June 9, 2023

City of Aurora
Planning and Development Services Dept
15151 E. Alameda Parkway, Suite 2300
Aurora, CO 80012

**RE: Antelope Creek (Kings Point North) 2nd Submission Review Response to Comments
CN#: 2022-6050-00; 2022-3081-00**

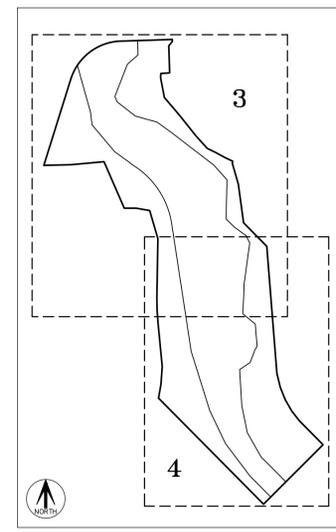
- q. Add second tie per COA 2022 Subdivision Plat Checklist.
RESPONSE: Tie added
- r. Site Plan shows 66' ROW?
RESPONSE: The 55' shown is correct.
- s. Site plan shows existing 20' utility easement per Chenango Filing No. 3?
RESPONSE: Site plan incorrect, there is an 8' UE per plat note
[Plat Page 3]
- t. Contact Andy Niquette releaseeasements@auroragov.org for the easement concerns.
RESPONSE: Noted
- u. Site plan shows existing 20' utility easement per Chenango Filing No. 3?
RESPONSE: Site plan incorrect, there is an 8' UE per plat note
- v. Site Plan shows differing geometry?
RESPONSE: Updated per site plan
[Plat Page 4]
- w. Contact Andy Niquette releaseeasements@auroragov.org for the easement concerns.
RESPONSE: Noted

Site plan shows existing 20' utility easement per Chenango Filing No. 3?

add second tie per COA 2022 Subdivision Plat Checklist

Site Plan shows 66'?

Plat note states it is an 8' UE on this side and 15' UE & DE along adj. ROW. Easements added

Added
